**PROPOSAL FOR DRAFT AMENDMENT TO REGULATION No. 13
(M, N AND O BRAKING SYSTEMS)**

Annex 12,

Figure 1. The test layout, showing prevention of wheel rotation and application of side load

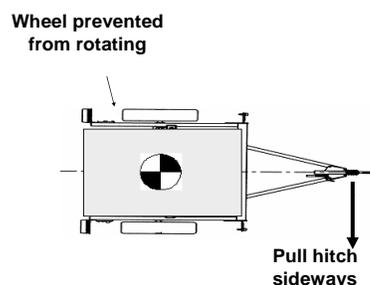
8.2. Prevent one of the wheels from rotating to ensure that the brakes on only one side of the trailer are forced to operate in the reverse direction (see figure 1 below).

Following this test the parking brake should be released and the brakes re-settled prior to repeating the test on the wheel(s) on the other side of the axle(s) with the test layout requirements reversed.

- 8.2.1. Any resistance from the jockey wheel shall be removed as far as is practicable and the minimum load as calculated in paragraph 8.4. is applied at 90° to the tow-hitch in the direction opposite from the side of the trailer to where the wheel(s) are prevented from rotating.
- 8.3. The load is increased until the trailer starts to rotate or the minimum force is reached. The method of applying the load to the tow hitch must ensure that there is no reduction in the gradient simulation force, even when the trailer begins to move. The limited movement typically 50mm associated with the operation of the auto-reverse mechanism is ignored in this respect.
- 8.4. Calculation of the minimum required gradient force
 - 8.4.1. Calculate the minimum gradient force F_{app} required at the tow hitch to guarantee adequate performance from each brake.
